Bat Specialist Report

for the final layout of the proposed Iziduli Emoyeni Wind Energy Facility

IWS Ref No: 3037

Date: 6 June 2022

Figure 1 IWS' May 2018 GPS tracks (pink) in relation to the final proposed layout of infrastructure for the Iziduli Emoyeni WEF

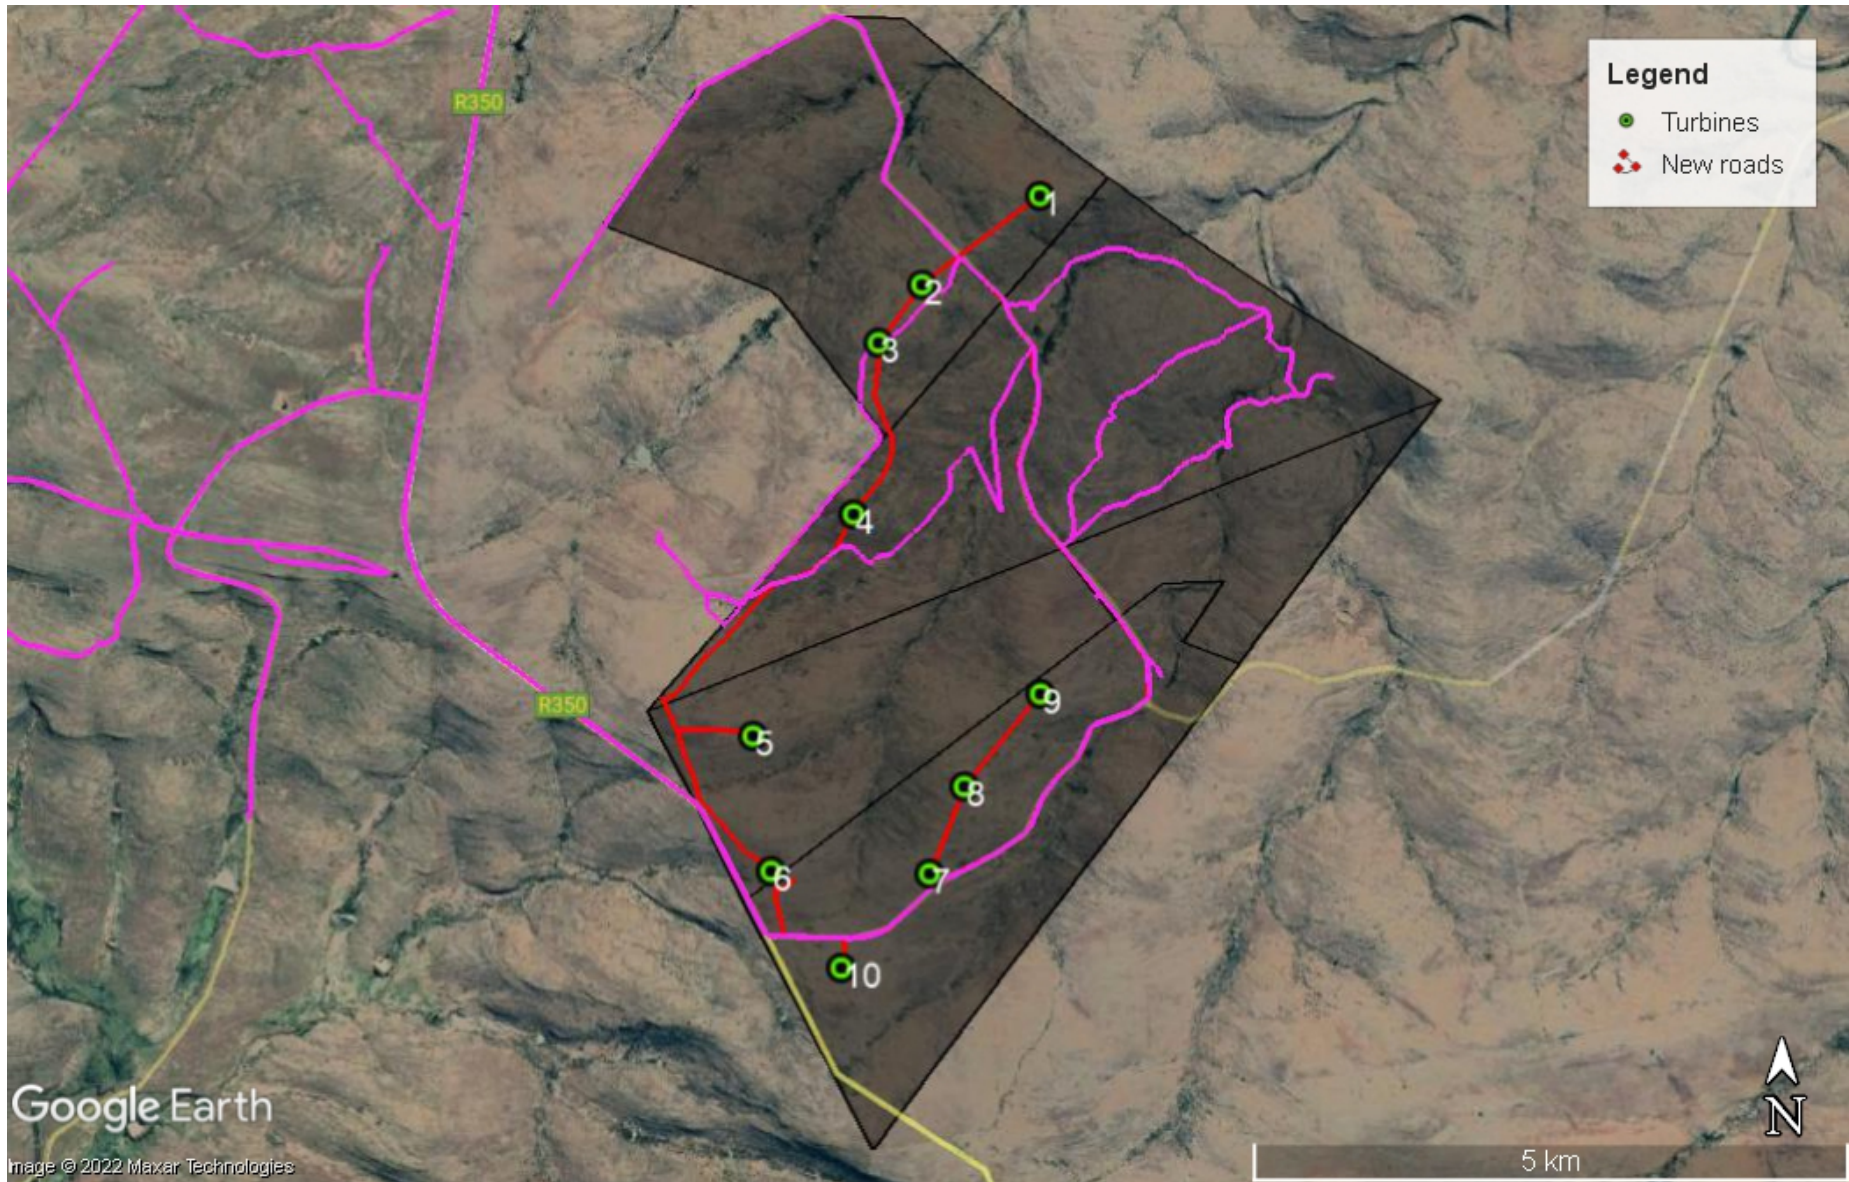
Shown in **Figure 1** are IWS' GPS tracks from the May 2018 walkthrough, in relation to the final layout of turbines for the proposed Iziduli WEF. The IWS (2022a) bat sensitivity map for the site is presented in **Figure 2**. Bat sensitivities associated with the 10 proposed turbine positions for the Iziduli WEF are summarized in **Table 1**.

At all 10 proposed turbine positions, the turbine bases and (maximum 80 m) blades will be wholly situated in Medium bat sensitive areas. Therefore, the 10 proposed turbine positions may remain unchanged from a bat impact perspective.

Figure 2 IWS (2022a) bat sensitivity map for the proposed Iziduli WEF

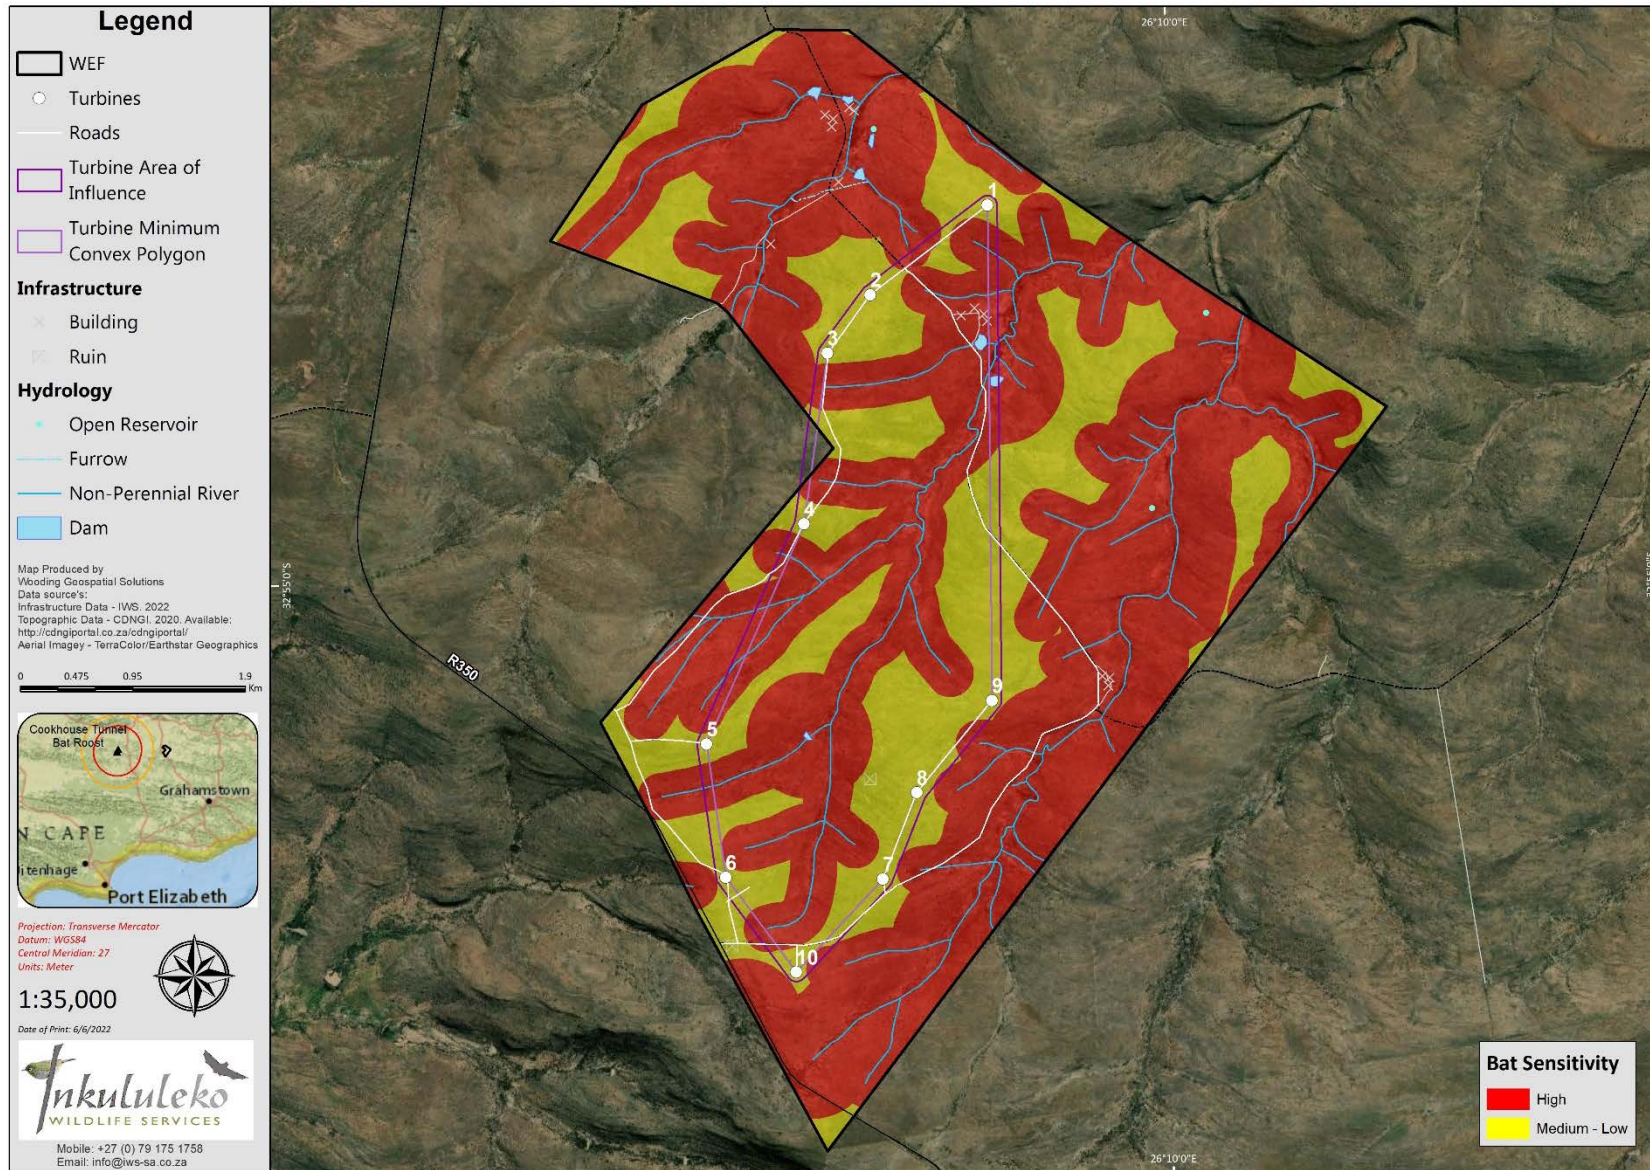
The Iziduli WEF site is situated in the Drakensberg Montane Grasslands, Woodlands, and Forest ecoregion and since the 10 x 80 m-blade turbines will have a 1 034 ha Area of Influence as shown in **Figure 2**, the bat fatality threshold for this WEF has been calculated according to the MacEwan *et al.* (2018) guidelines as:

0.2 bat fatalities for every 10 ha x 1 034 ha / 10 ha = 20.68 bat fatalities per annum

IWS confirms that bat sensitivity recommendations have been properly considered in designing the final layout of the Iziduli WEF, and that the 10 proposed turbine positions under the final layout may remain unchanged from a bat impact perspective.

The calculated threshold should be included in the project Environmental Management Programme (EMPr), together with the condition that the bat fatality threshold may only be re-calculated if there is a change in the turbine layout and/or the turbine blade length, and/or when newer threshold guidance is published.
